## 2019 Project Review Sheet (2020 Construction)

<b>Project #</b>	19-298
<b>Project Title:</b>	Add better lighting
<b>Location:</b>	Neighborhood: Queen Anne, 98109 Area: Intersection of Galer St and Taylor Ave N; the stairway up the hill from there (to the west).

YVYC 2019: Project 19-298, Intersection of Galer St and Taylor Ave N; the stairway up the hill from there (to the west).

Image:

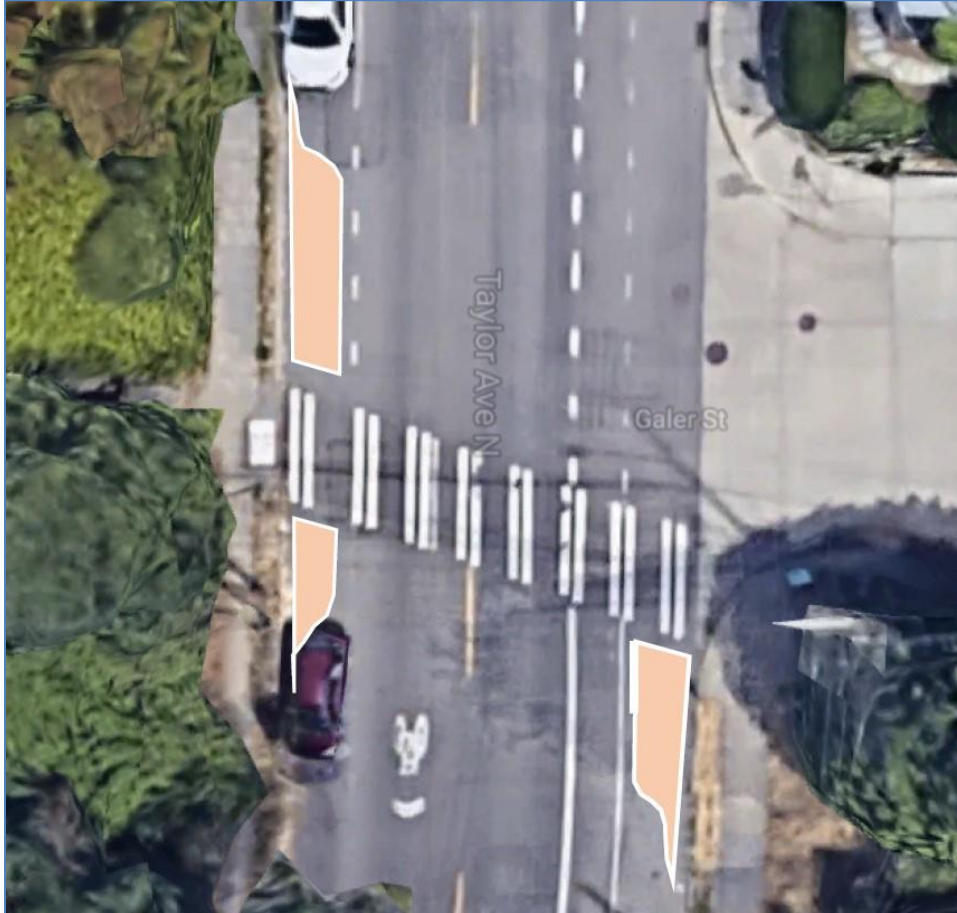
This project was reviewed for potential crossing improvements at the marked crossing on the south side of the intersection. SDOT evaluated the location for a raised crossing, but due to the existing grade of 6 percent and challenges with drainage associated with this type of treatment, SDOT does not support a raised crossing at this location. As an alternative installation of a Rectangular Rapid Flashing Beacon (RRFB) was evaluated. New speed and volume data were collected which showed an Average Weekday Traffic Volume (AWDT) of 4,600 vehicles per day and the 85<sup>th</sup> percentile speeds in the southbound direction of approximately 29.5 mph and 27.3 mph. in the northbound direction. Based on those conditions SDOT would not support installation of an RRFB.

An alternative to installation of an RRFB would be to install paint and post curb bulbs on the southeast corner and the west side of the intersection. Painted curb bulbs can help to reduce the crossing distance pedestrians and improve pedestrian visibility, which may help encourage greater compliance of motorists stopping for pedestrians.

SDOT also completed a lighting analysis for both the intersection and the stairwell. Per SDOT lighting guidelines, the lighting level criteria for the intersection of Taylor Ave N & Galer St is 3.0 foot-candles (fc) for LED street lighting and a uniformity (average/minimum) of 3.0 or less. The existing light level is 1.94 fc and 1.62 uniformity. As a result, SDOT would support installation of an additional streetlight on the west side of Taylor Ave N and Galer St.

The lighting level criteria for pedestrian facility is 1.0 fc for an LED light source and a uniformity of 4.0 or less. The existing light level along the stairway is 0.03 fc with no uniformity. SDOT would support installation of additional pedestrian lighting along the stairway.
